REMARKS/ARGUMENTS

The following remarks address the objections and rejections contained in the Office Action mailed June 3, 2004.

Application Serial No.: 10/046,959 Amendment filed November 3, 2004 Reply to Office Action of 06/03/2004 Annotated Sheet Showing Changes/ Figure 1

Figure 1

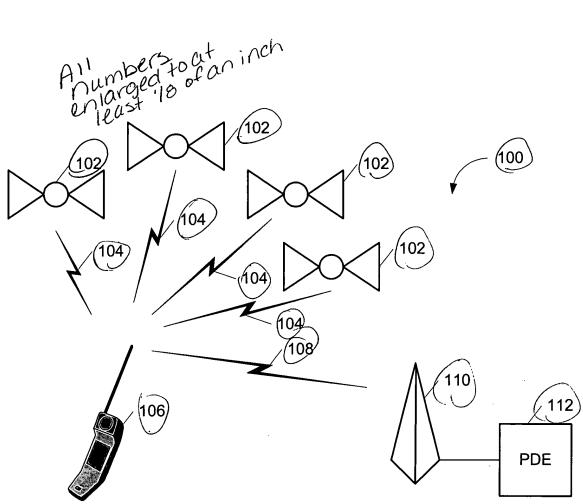
Paragraph 2 of the Action noted that the Draftsperson has objected to the drawings.

The attached sheet of drawings includes changes to Figures 1-4 and 11. Applicant believes that the numbers, letters, and reference characters in each of these figures complies with the height requirement of 37 C.F.R. 1.84(p)(3).

Figure 3

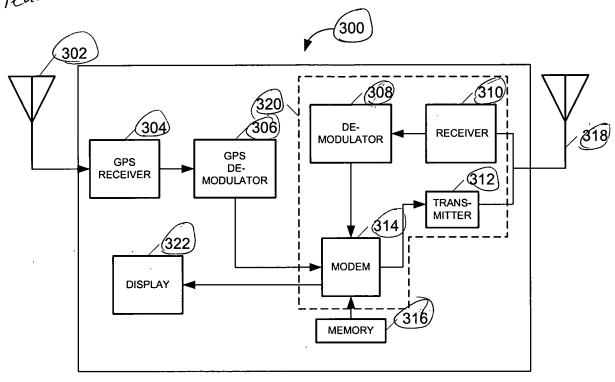
All numbers enlarged to at least 18 of an inch
